**CONSTRUCTION CONTRACT CHANGE ORDER NUMBER:** \_\_\_\_\_

CCSJ:	<u>0921-02-321</u>
Project:	<u>STP 2021(256) MM</u>
Highway:	<u>Mile 3 N</u>
County:	<u>Hidalgo</u>
District:	<u>21-Pharr</u>
Contract Number:	<u>C-20-294-02-23</u>

## Change Order #5 Mile 3 N Road

Project: Mile 3 N Road  
Project #: STP 2021 (256) MM  
Contract: C-20-294-02-23  
CSJ: 0921-02-321  
Limits: Tom Gill Road to FM 492 (Goodwin Road)

MILE 3 ROAD  
PLAN AND PROFILE  
STA. 225+50 TO STA. 230+50

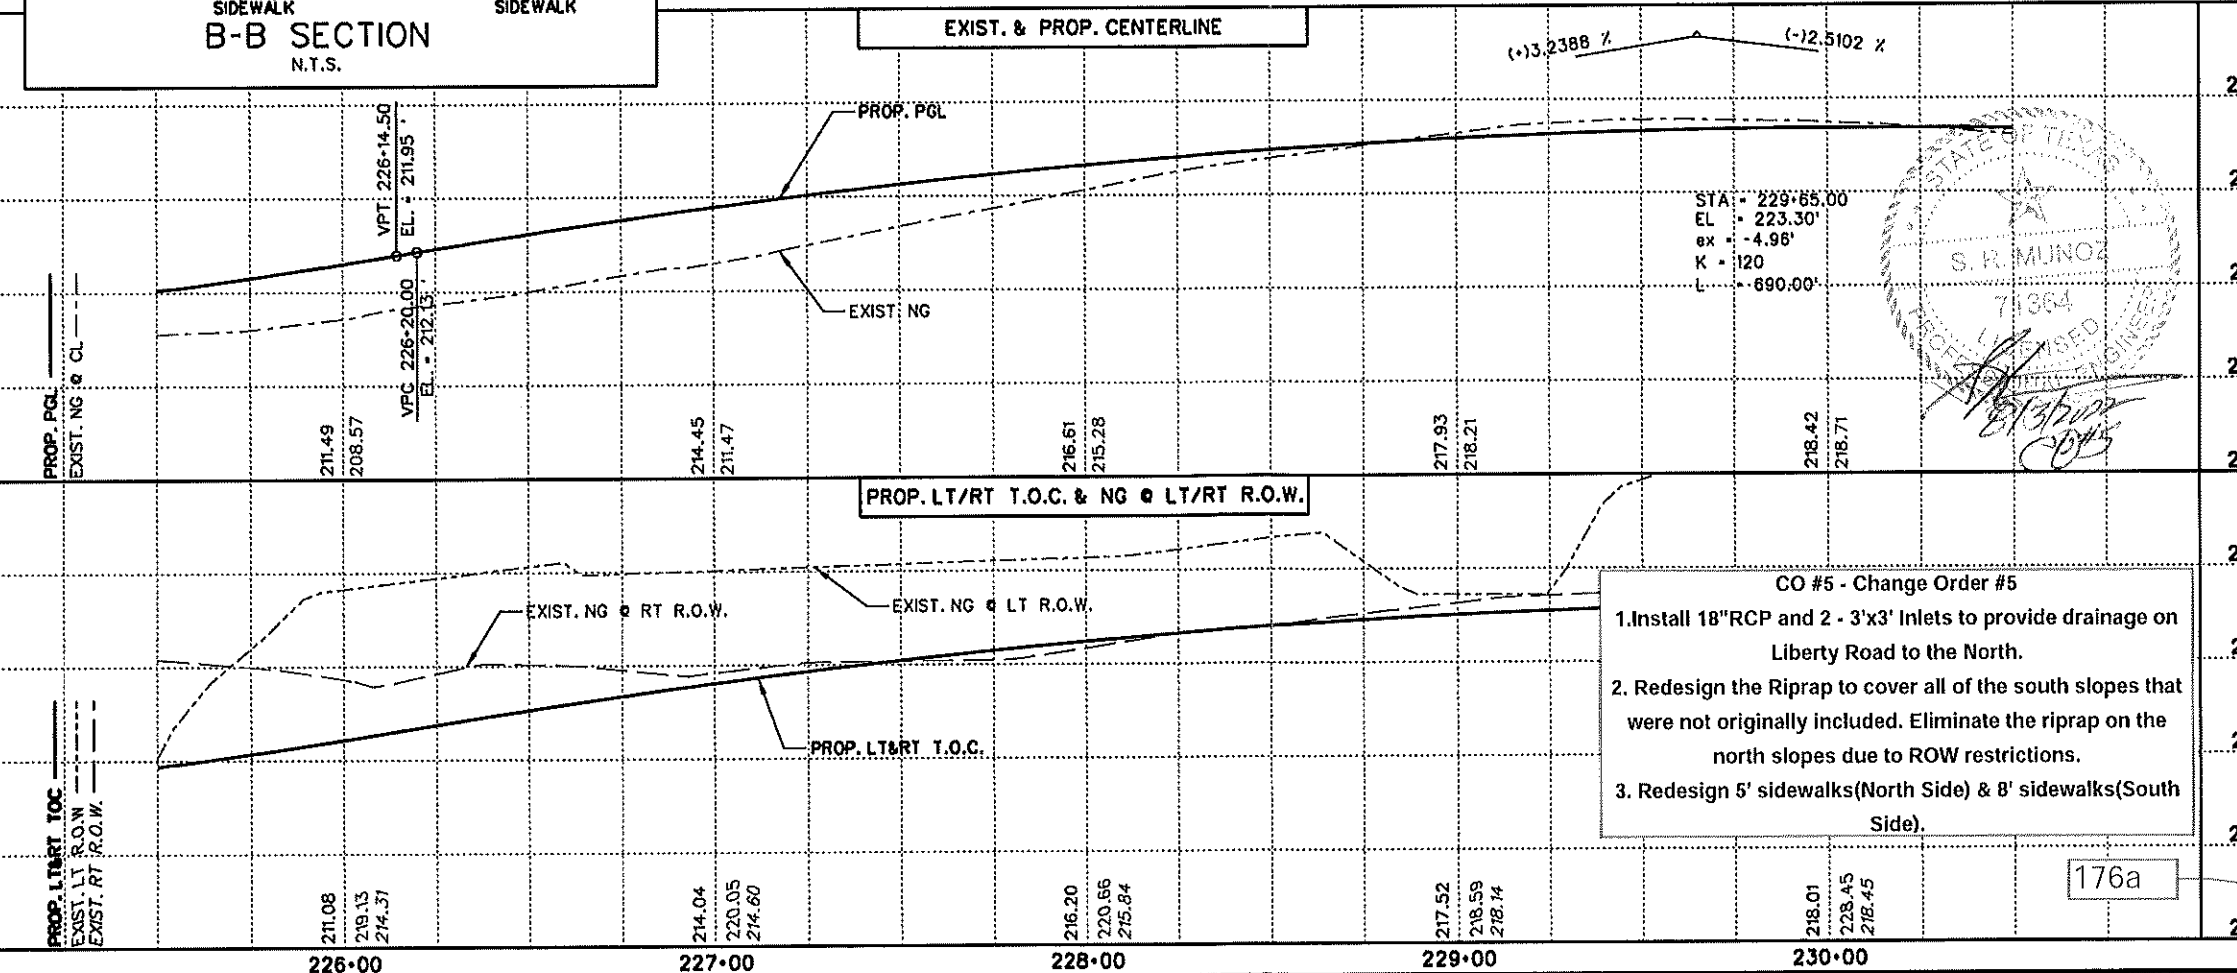
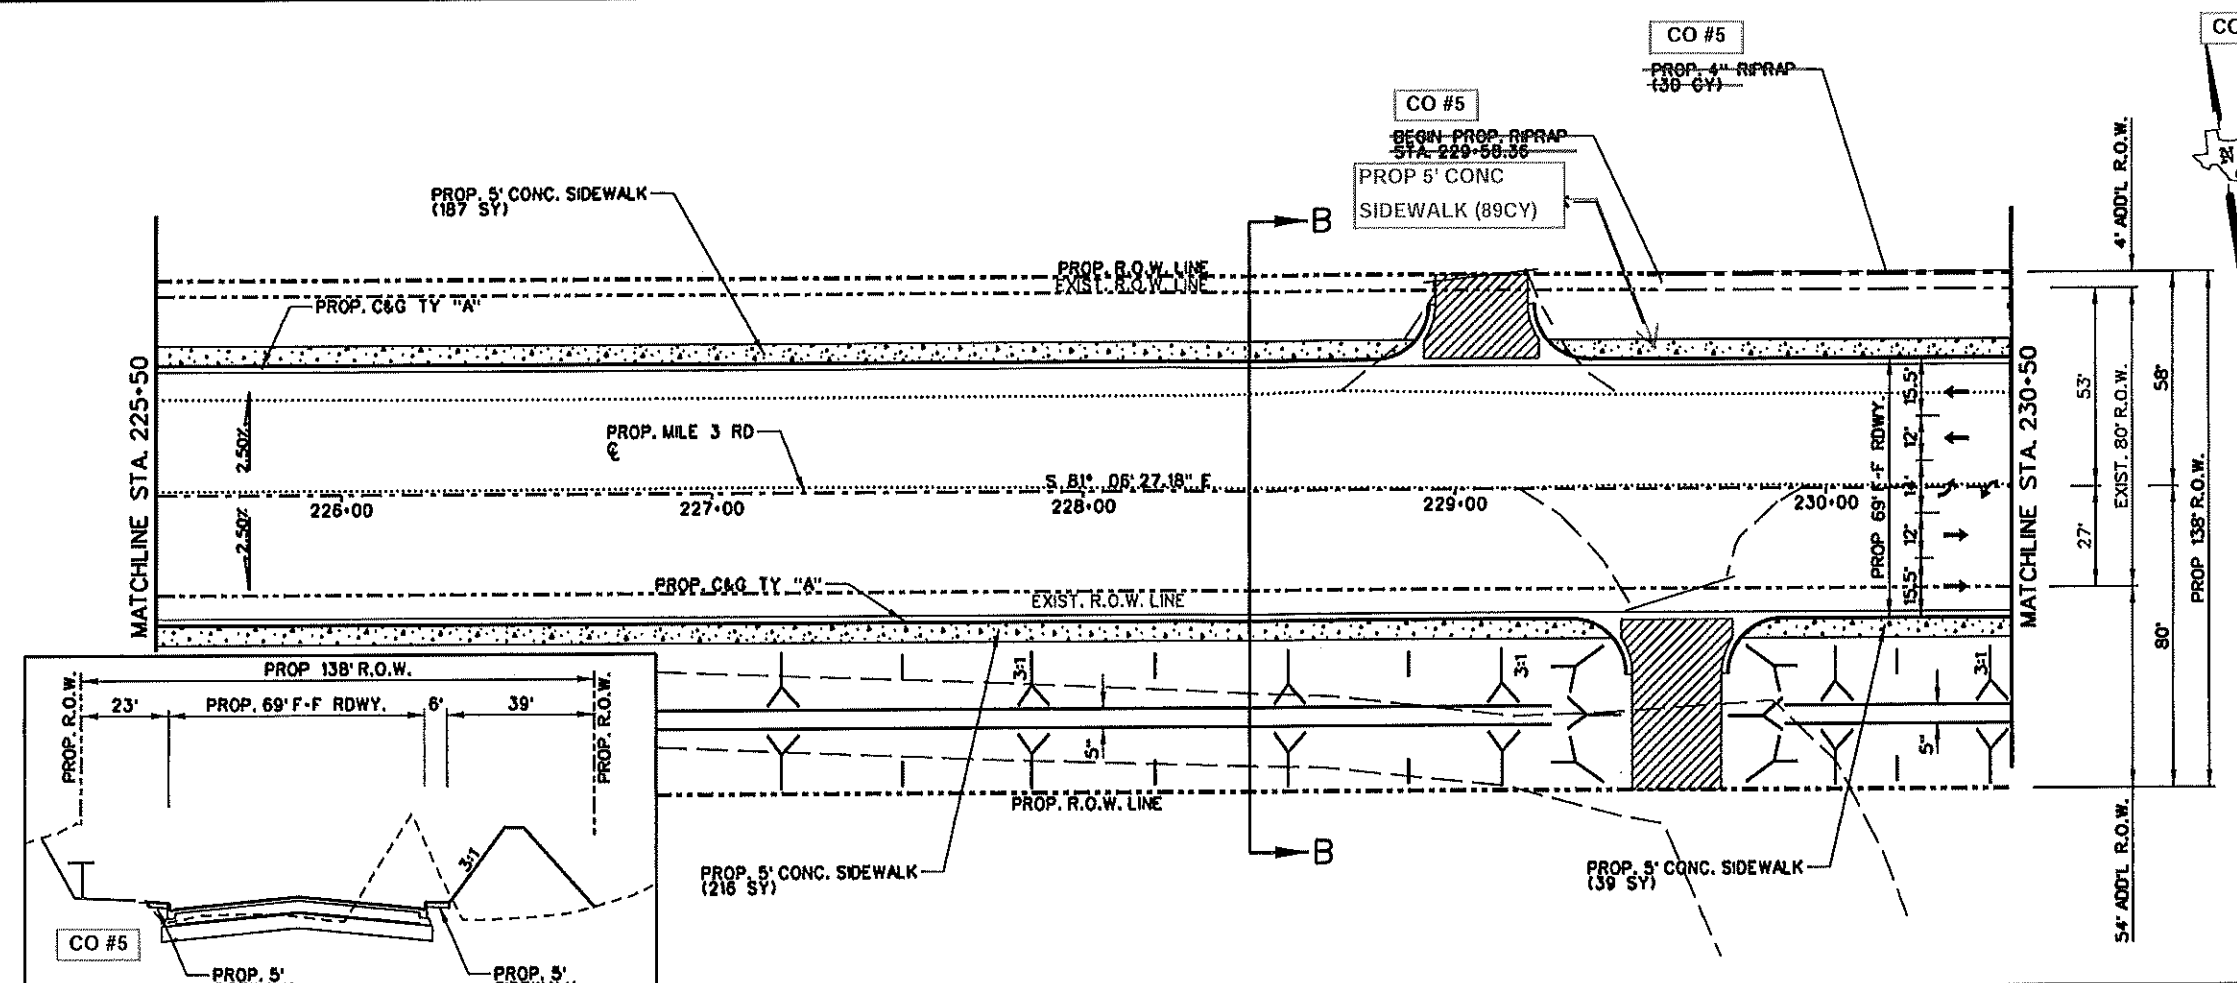
1. Install 18" RCP and 2 - 3'x3' Inlets to provide drainage on Liberty Road to the North.
2. Redesign the Riprap to cover all of the south slopes that were not originally included. Eliminate the riprap on the north slopes due to ROW restrictions.
3. Redesign 5' sidewalks (North Side) & 8' sidewalks (South Side).

**MILE 3 ROAD  
 PLAN AND PROFILE  
 STA. 230+50 TO STA. 235+50**

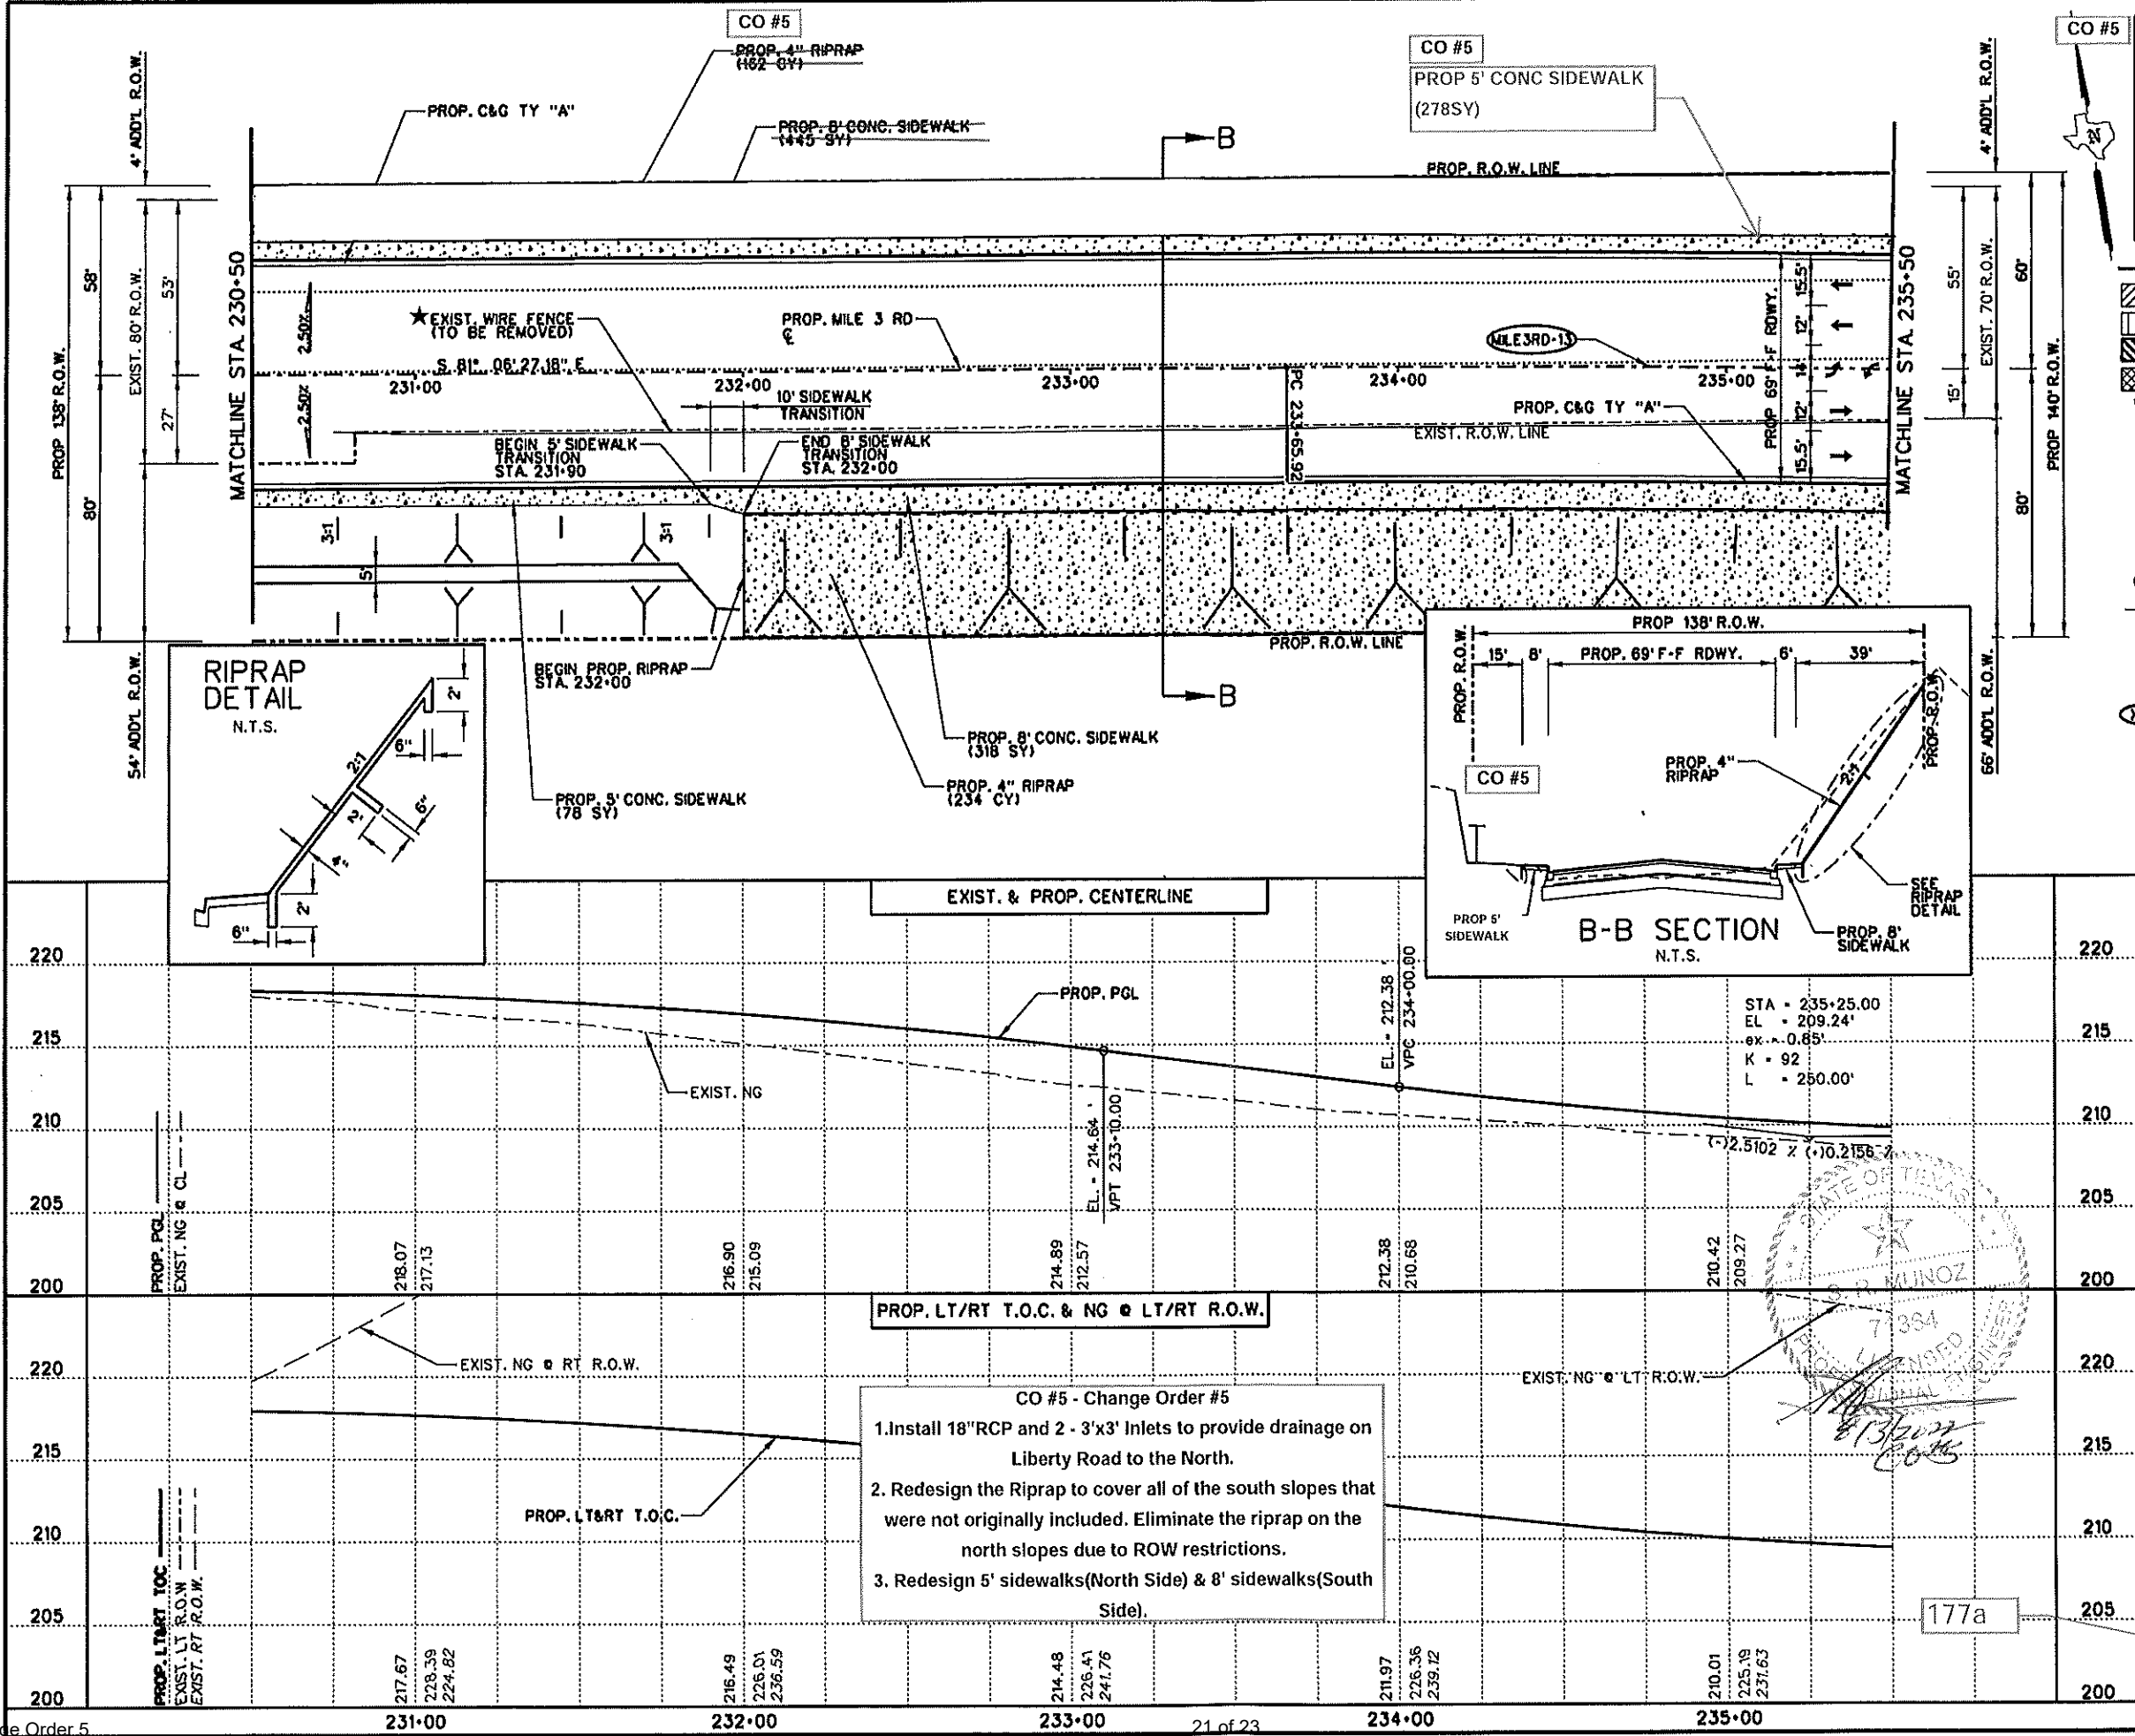
1. Install 18" RCP and 2 - 3'x3' Inlets to provide drainage on Liberty Road to the North.
2. Redesign the Riprap to cover all of the south slopes that were not originally included. Eliminate the riprap on the north slopes due to ROW restrictions.
3. Redesign 5' sidewalks (North Side) & 8' sidewalks (South Side).
